**PLANNING COMMISSION
Regular Meeting
Monday, November 22, 2021
6:00 PM
Christine Nuernberg Hall**

TO: Planning Commission
FROM: PA PHOUALA VANG, PLANNER
DATE: November 22, 2021
SUBJECT: North Shore Bank. The applicant is seeking conditional use grant extension approval for the previously approved bank building with a rear drive-through for the property located at 11319 N. Port Washington Road. This was previously approved in October 2020.

TO: Planning Commission
FROM: PA PHOUALA VANG, PLANNER
DATE: November 22, 2021
SUBJECT: Applied Buildings, LLC. The applicant is seeking building and site plan and fill approval for a proposed 36,843 sq. ft. multi-tenant office/warehouse building and certified survey map approval to allow for a 3-lot land division for the property located a 5715 W. Donges Bay Road.

LANDSCAPE DI AN OVERVIEW

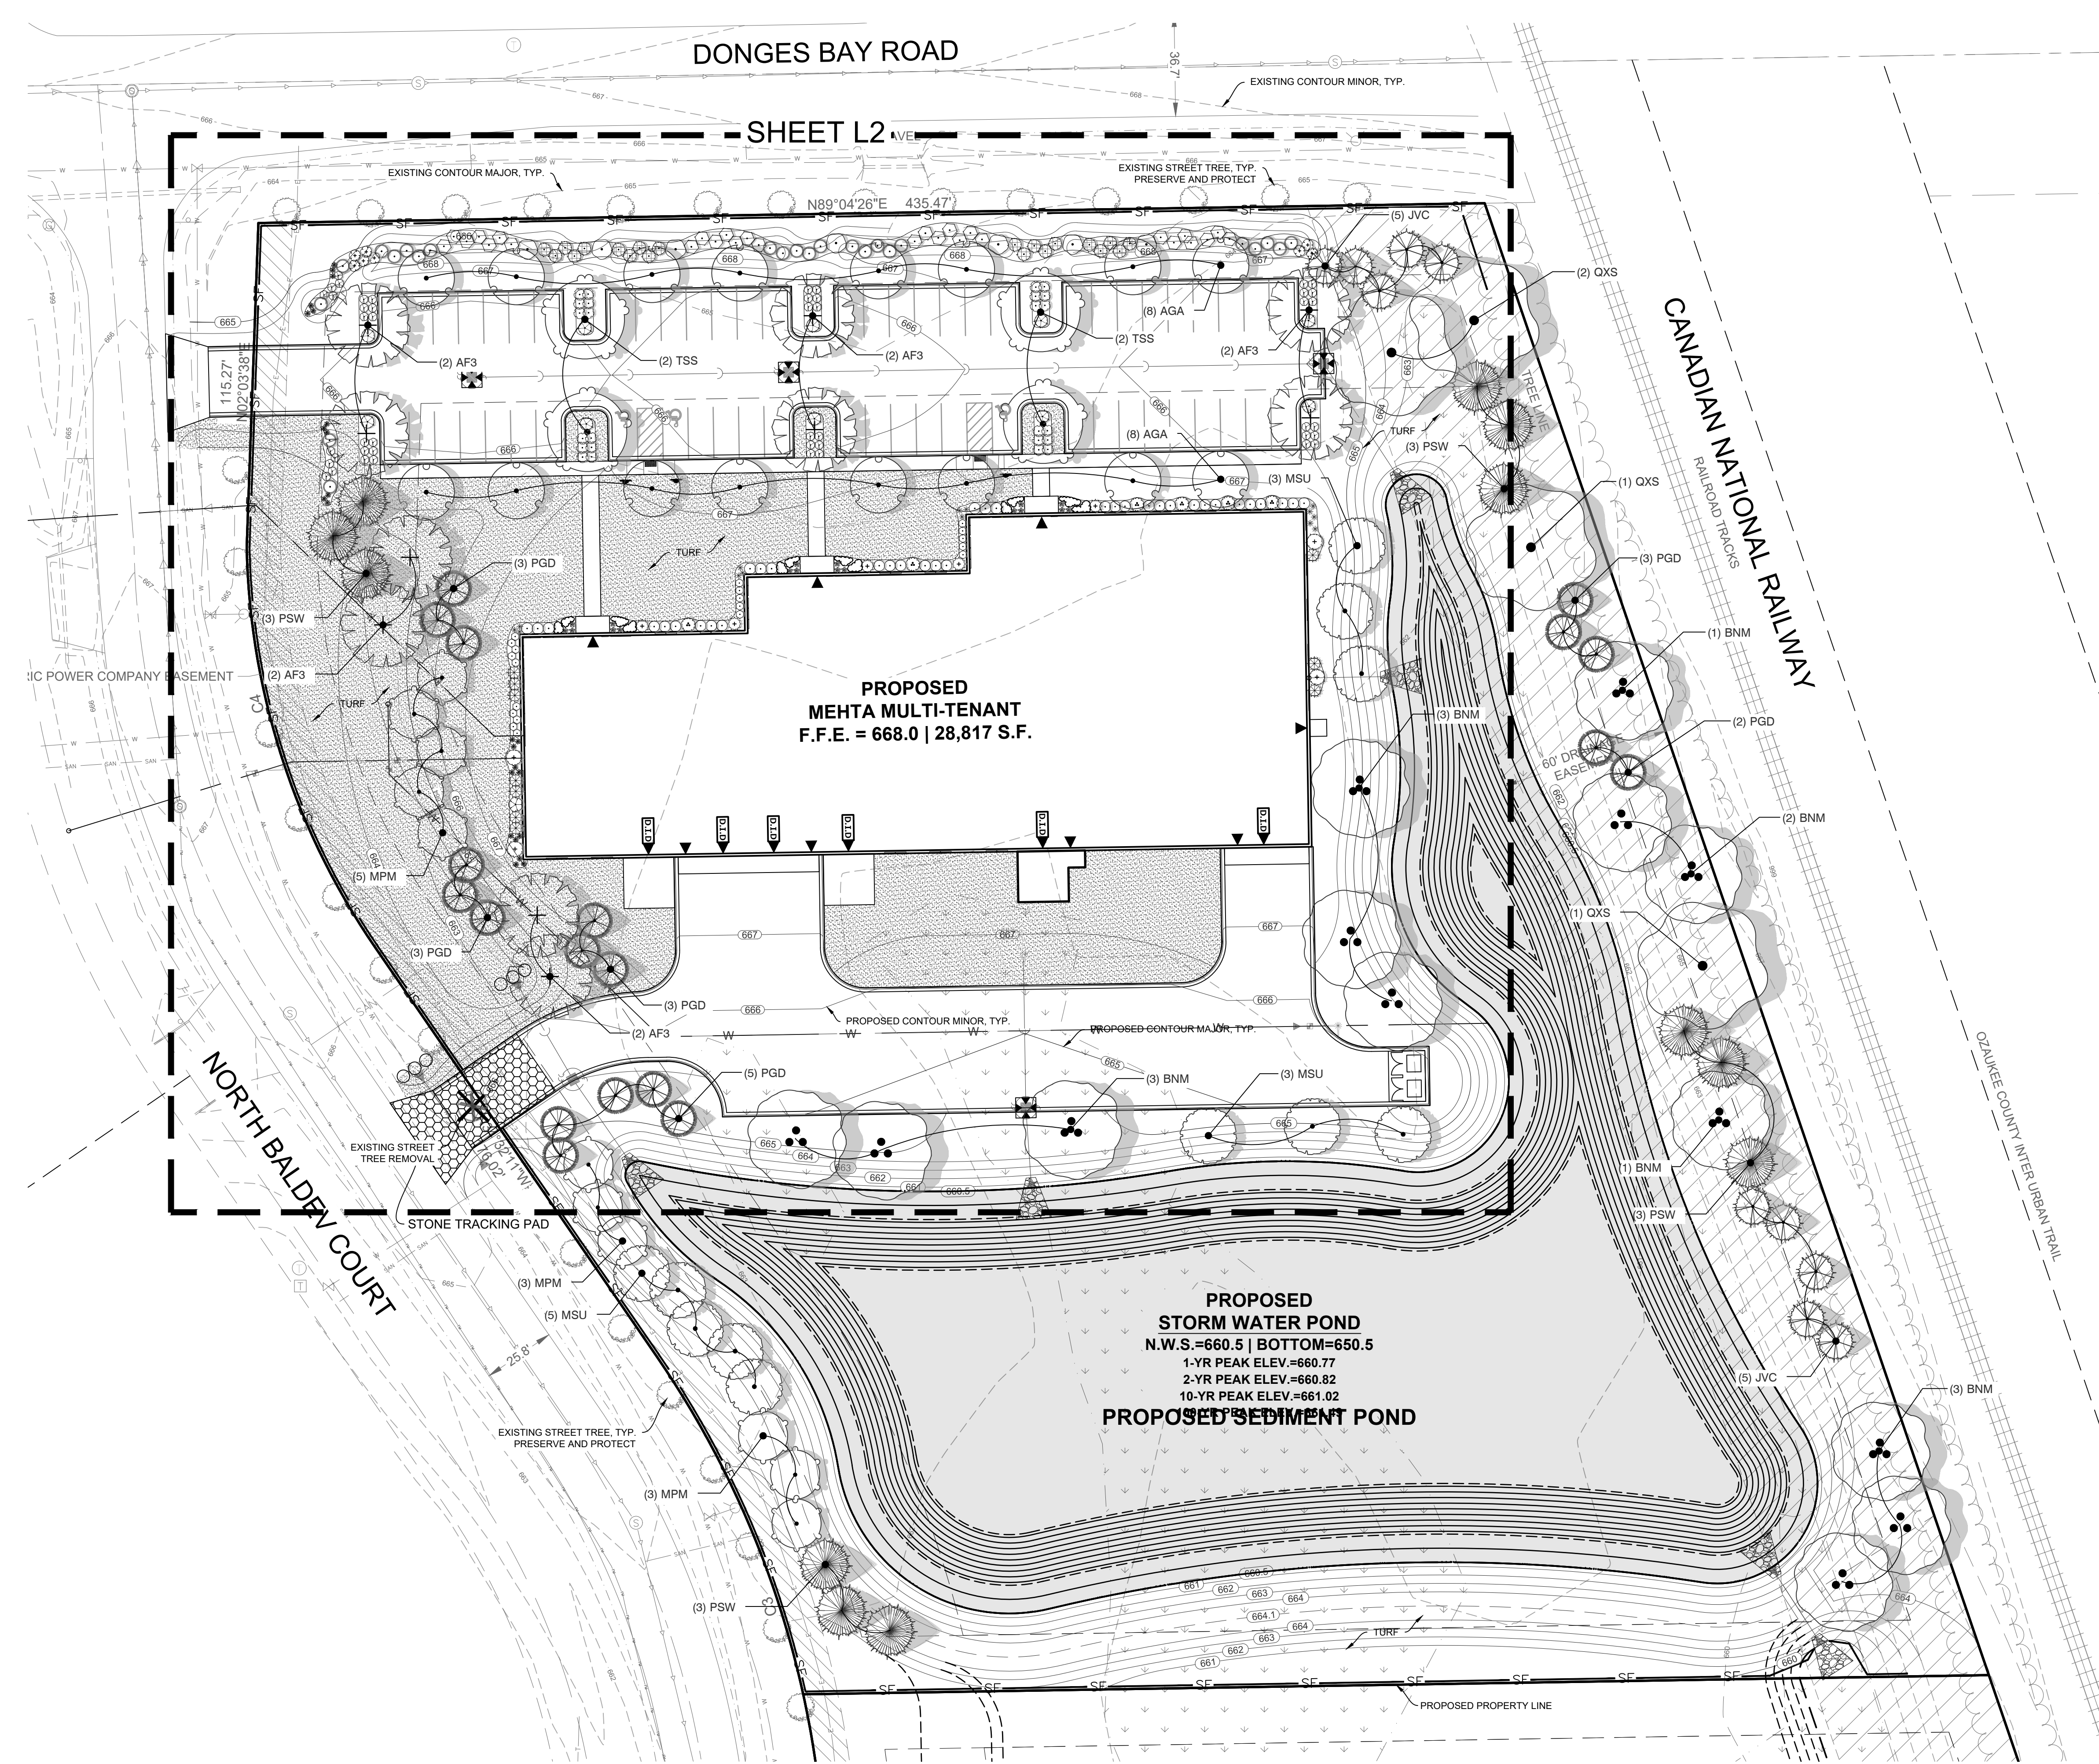
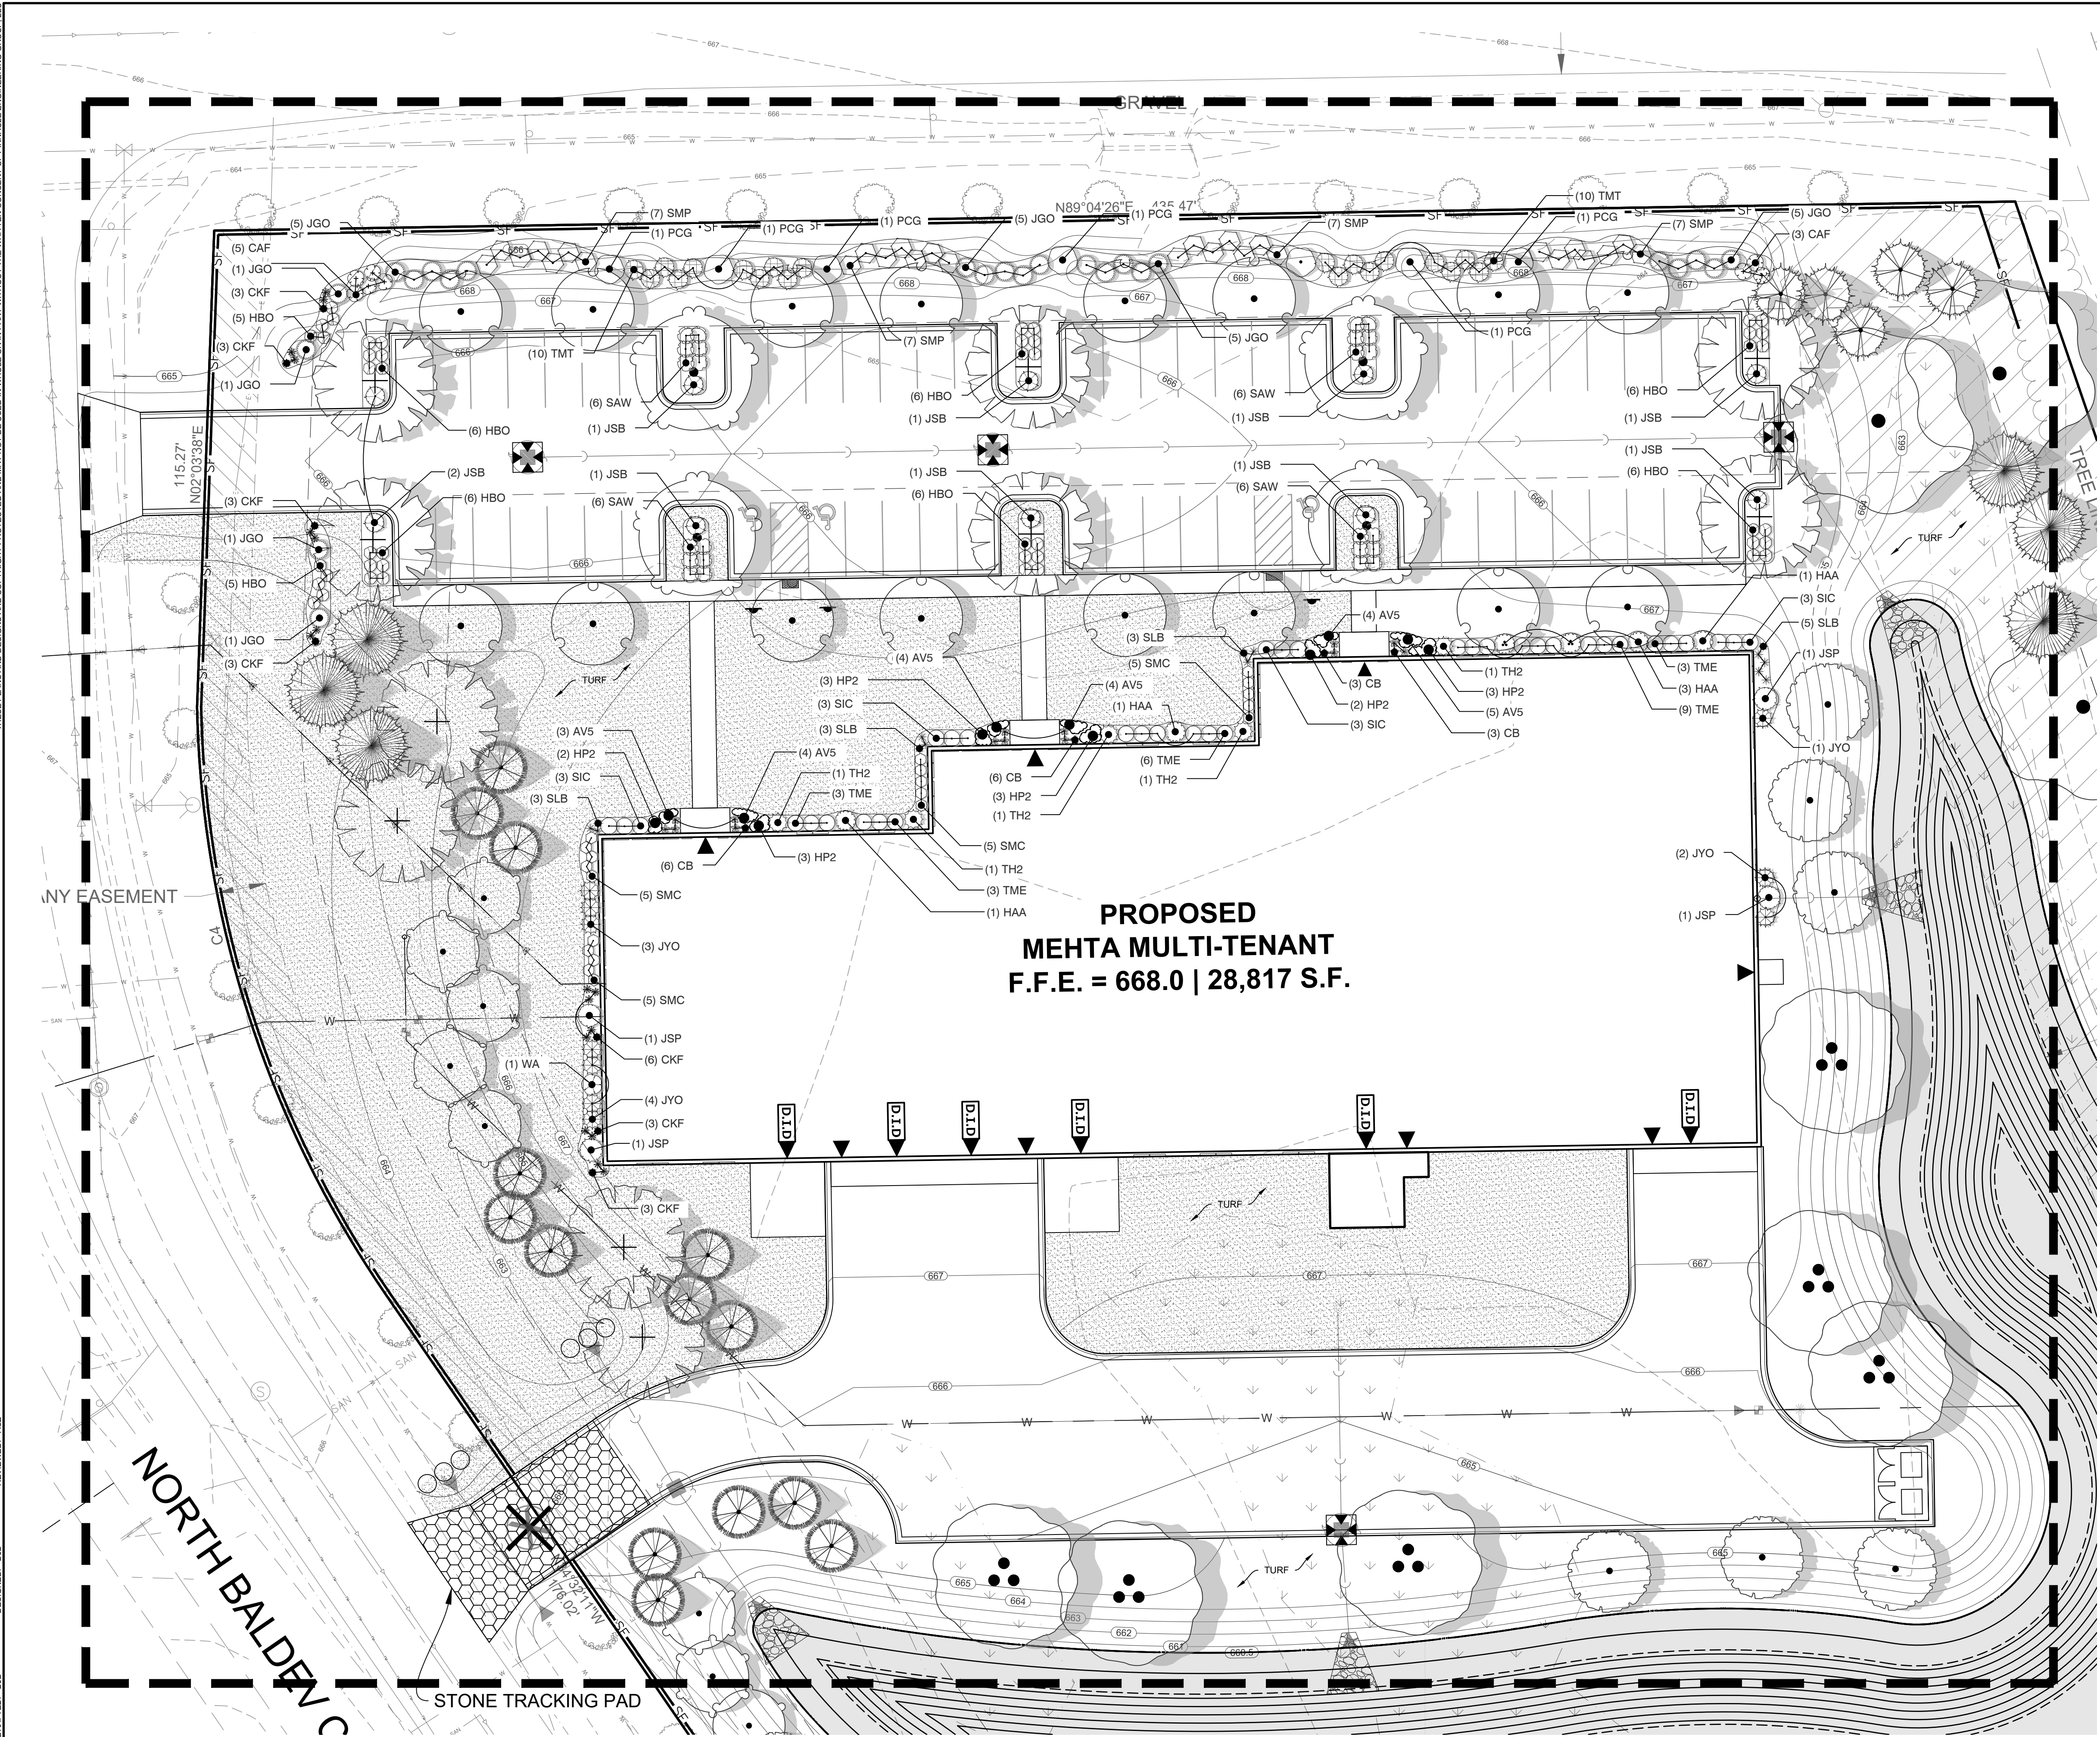
Landscape consultant, Michael T. Higgins, reviewed the plan for conformance with the code. Based upon the consultant's review, staff will recommend the following:

2. Minimum 3-inch caliper for all deciduous trees.
3. Minimum 7 feet height for all conifer trees.
4. Additional landscape treatment along entire south property line to include a mix of canopy and conifer trees to be shown on revised landscape plan for staff review and approval.
